Upd: 22 NOV 2005

**02A**

7726000 - 02A - 02A-5300

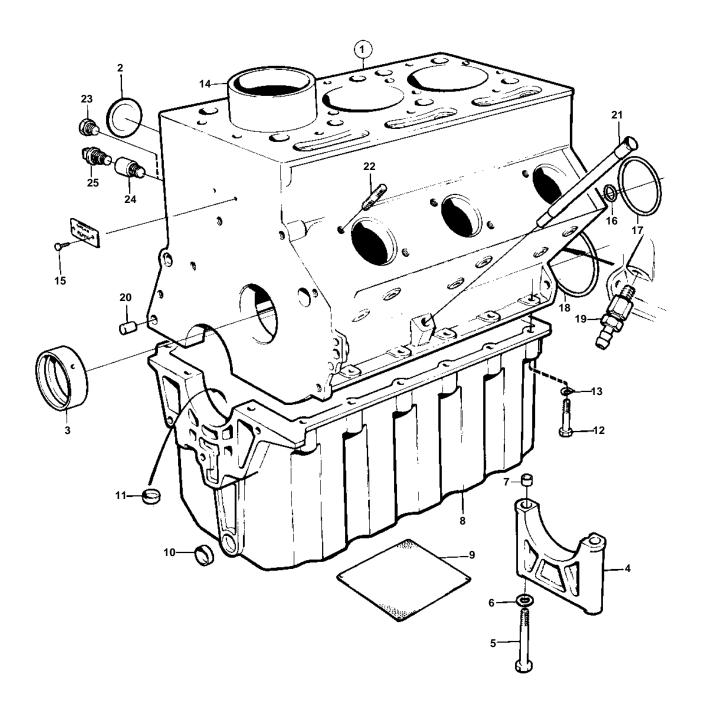
REF	PART NO.	QTY	DESCRIPTION		SEE SEC.	NOTES
1	858498	1	Cylinder block			REPLACED BY 1EA CYLINDER BLOCK 860235,3EA O-RINGS 97896
						FOR SEALING OF FUEL INJECTION PUMPS + SPACER 6EA
						860211 TJ=0,20MM,3EA 838298 TJ=0,30MM,3EA 838299 TJ=0,
						60MM AND 3EA 838300 TJ=0,90MM.
						SN-2300041589
					02A-5320	
2	477024	3	<ul> <li>Expansion plug</li> </ul>			(192211)
3	463360		Bushing			
4		2	BEARING CAP			
5	963257		· Screw			
6	840210	8	Washer			
7	3875305	6	Guide sleeve			
8	33.333	1	OIL SUMP			*
9	840588	1				*
10	840713	1				
11	946778	1	Cap plug			
12	955300		Screw			
13	941907	12	Spring washer			
14	840889	14	Cylinder liner			
15	950885	2			1	
16	943177	1		IK		
17	943177	1		IK		
	967590					
18	967592	1		IK		
19	947893	1	Drain cock			
20	950586	4				
21	840846	1				
22	924061		Stud			
23	192154	1				(000470) (050504)
24 25	838929 838928	1	Zinc anod Plug			(800476) (858501) (800475)
